Remarks

Objections to the Drawings

Fig. 1 has been amended as follows:

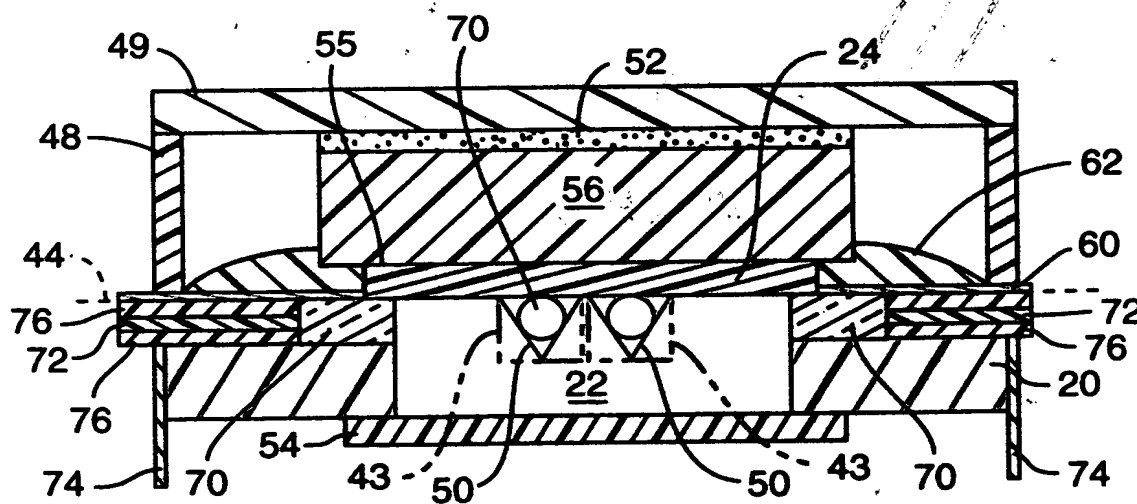
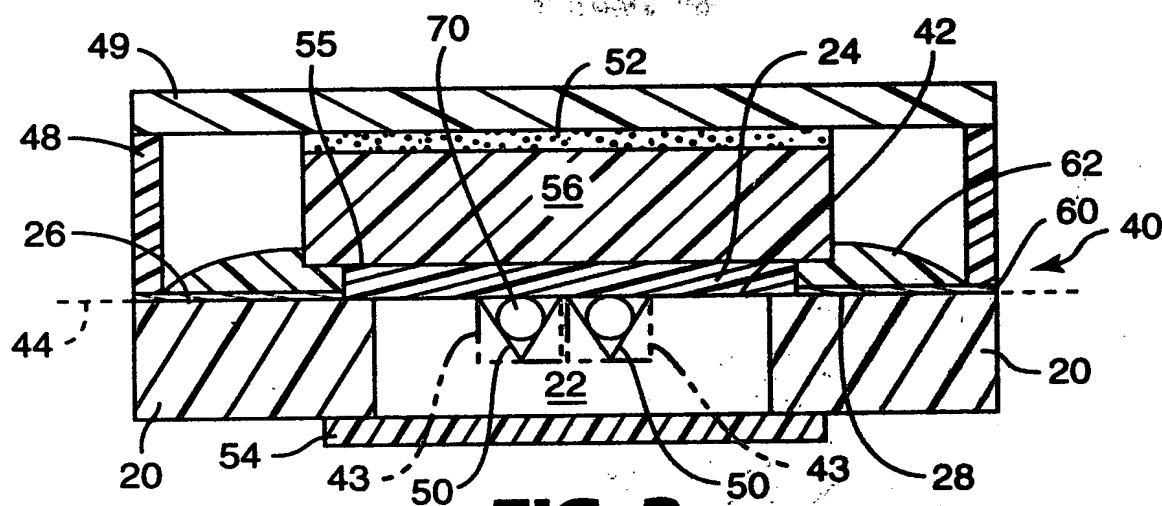
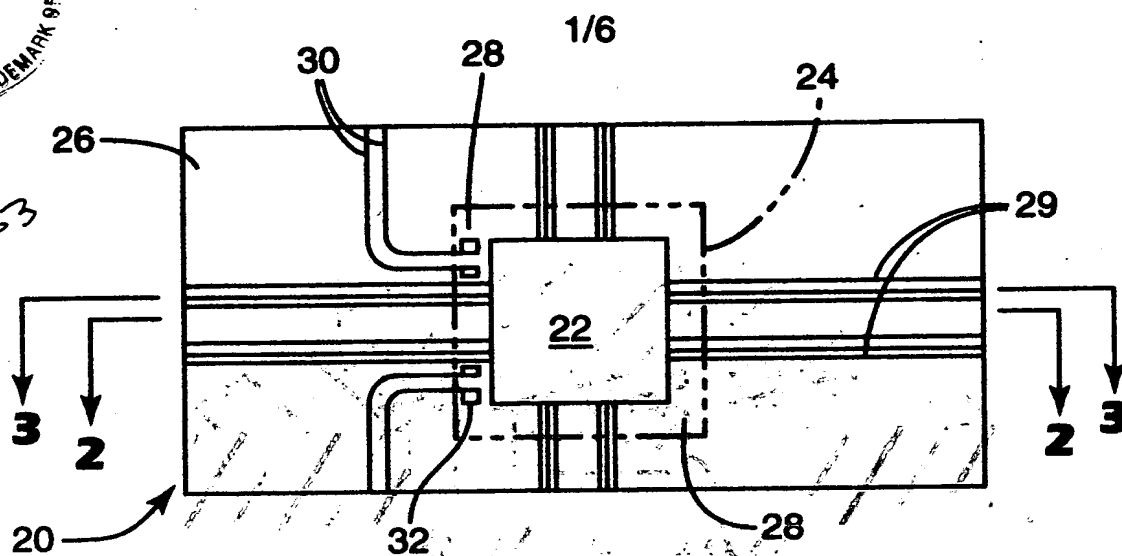
The line format of the die (24) has been changed to “phantom.” Support for this amendment is found on page 6, lines 23-24.

Fig. 2 has been amended as follows:

The cross-hatching of the package frame (20) has been changed to indicate an insulative part. Support for this amendment is found at page 7, lines 7-24.

The cross-hatching has been removed from the aperture (22). Support for this amendment is found at page 9, lines 28-31.

The line format for optical micro-mechanical devices (43) has been changed to “phantom.” Support for this amendment is found at page 7, line 31-page 8, line 1.

The cross-hatching for the flex circuit (60) has been changed to indicate a conductive material. Support for this amendment is found at page 8, lines 24-26.

The cross-hatching has been removed from the lenses (70) shown in end-view. Support for this amendment is found at page 2, lines 27-31.

Fig. 3 has been amended as follows:

The cross-hatching of the package frame (20) has been changed to indicate an insulative part. Support for this amendment is found at page 7, lines 7-24.

The cross-hatching has been removed from the aperture (22). Support for this amendment is found at page 9, lines 28-31.

The line format for optical micro-mechanical devices (43) has been changed to “phantom.” Support for this amendment is found at page 7, line 31-page 8, line 1.

The cross-hatching for the flex circuit (60) has been changed to indicate a conductive material. Support for this amendment is found at page 8, lines 24-26.

The cross-hatching has been removed from the lenses (70) shown in end-view. Support for this amendment is found at page 2, lines 27-31.

FIG. 4

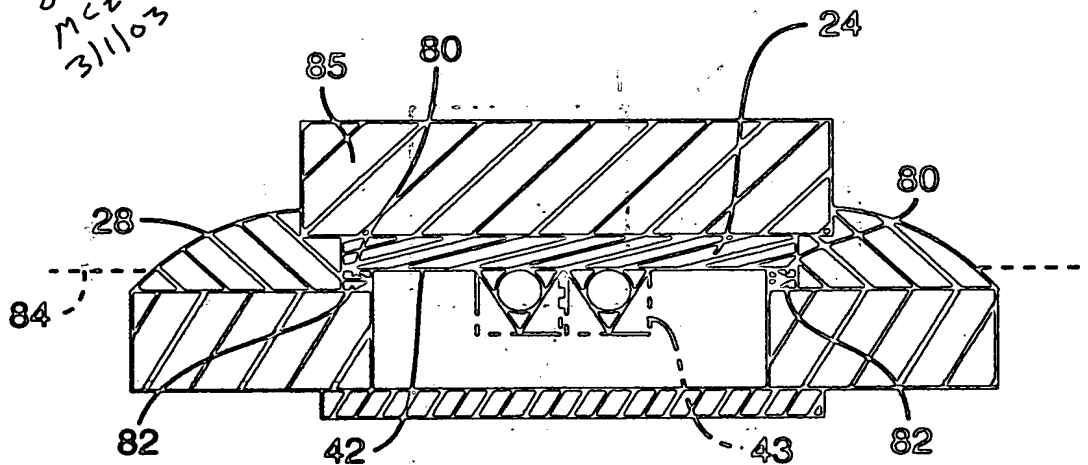
Fig. 4 has been amended as follows:

The cross-hatching of the package frame has been changed to indicate an insulative part. Support for this amendment is found at page 7, lines 7-24.

The cross-hatching has been removed from the aperture. Support for this amendment is found at page 9, lines 28-31.

The line format for optical micro-mechanical devices (43) has been changed to “phantom.” Support for this amendment is found at page 7, line 31-page 8, line 1.

The cross-hatching has been removed from the lenses shown in end-view. Support for this amendment is found at page 2, lines 27-31.

FIG. 5

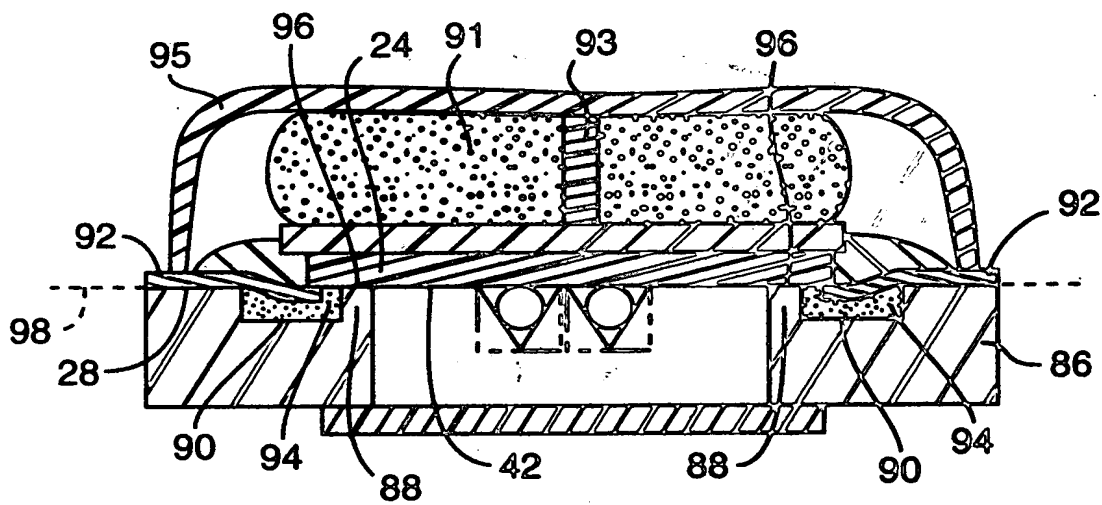
Fig. 5 has been amended as follows:

The cross-hatching of the package frame (86) has been changed to indicate an insulative part. Support for this amendment is found at page 7, lines 7-24.

The cross-hatching has been removed from the aperture. Support for this amendment is found at page 9, lines 28-31.

The line format for optical micro-mechanical devices has been changed to “phantom.” Support for this amendment is found at page 7, line 31-page 8, line 1.

The cross-hatching for the flex circuit (92) has been changed to indicate a conductive material. Support for this amendment is found at page 11, lines 4-6.

The cross-hatching has been removed from the lenses shown in end-view. Support for this amendment is found at page 2, lines 27-31.

FIG. 6

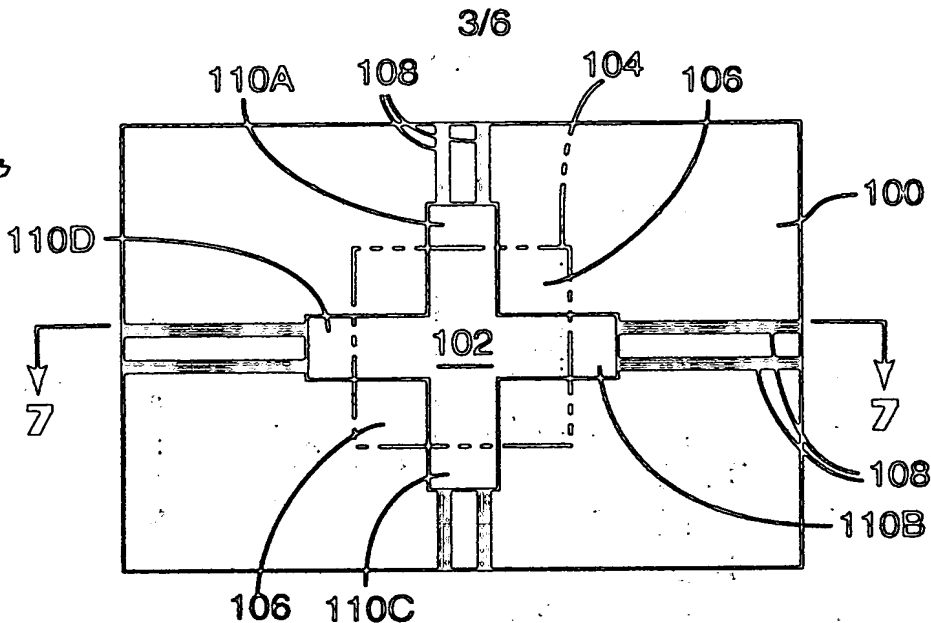
Fig. 6 has been amended as follows:

The line format for the die (104) has been changed to “phantom.” Support for this amendment is found at page 11, lines 30-31.

FIG. 7

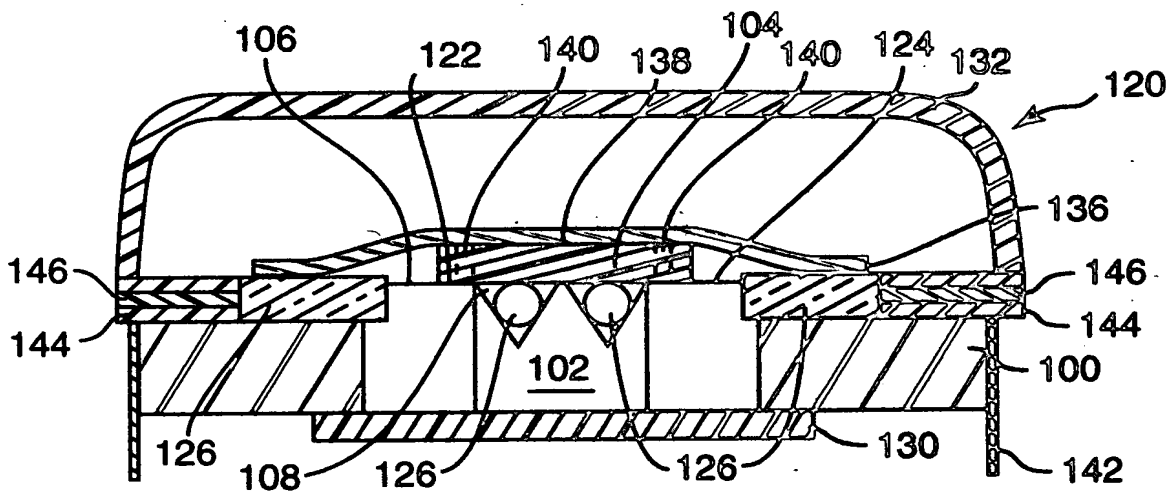
Fig. 7 has been amended as follows:

The cross-hatching of the package frame (100) has been changed to indicate an insulative part. Support for this amendment is found at page 7, lines 7-24.

The cross-hatching has been removed from the aperture (102). Support for this amendment is found at page 9, lines 28-31.

The cross-hatching for the flex circuit (136) has been changed to indicate a conductive material. Support for this amendment is found at page 12, lines 23-27.

The cross-hatching has been removed from the lenses (126) shown in end-view. Support for this amendment is found at page 2, lines 27-31.

FIG. 8

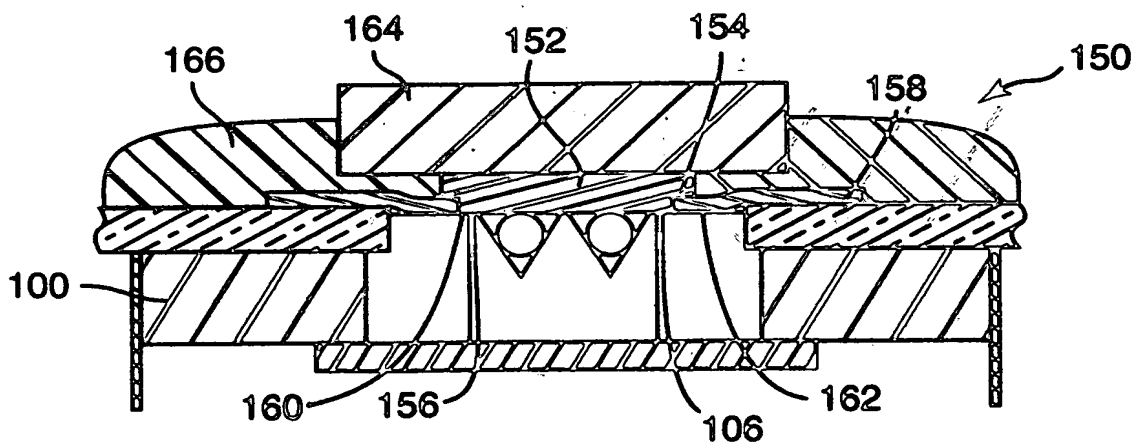
Fig. 8 has been amended as follows:

The cross-hatching of the package frame (**100**) has been changed to indicate an insulative part. Support for this amendment is found at page 7, lines 7-24.

The cross-hatching has been removed from the aperture. Support for this amendment is found at page 9, lines 28-31.

The cross-hatching for the flex circuit (**158**) has been changed to indicate a conductive material. Support for this amendment is found at page 13, lines 2-3.

The cross-hatching has been removed from the lenses shown in end-view. Support for this amendment is found at page 2, lines 27-31.

FIG. 10

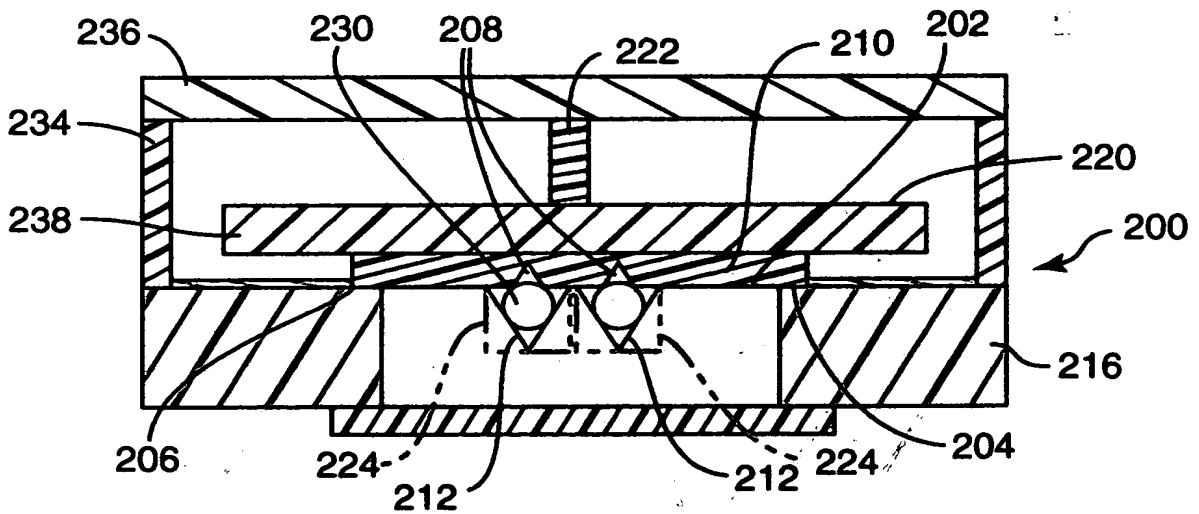
Fig. 10 has been amended as follows:

The cross-hatching of the package frame (**216**) has been changed to indicate an insulative part. Support for this amendment is found at page 7, lines 7-24.

The cross-hatching has been removed from the aperture. Support for this amendment is found at page 9, lines 28-31.

The cross-hatching for the flex circuit has been changed to indicate a conductive material. Support for this amendment is found at, e.g., page 13, lines 2-3.

The line format for optical micro-mechanical devices (**224**) has been changed to “phantom.” Support for this amendment is found at page 7, line 31 – page 8, line 1.

The cross-hatching has been removed from the lenses (**230**) shown in end-view. Support for this amendment is found at page 2, lines 27-31.
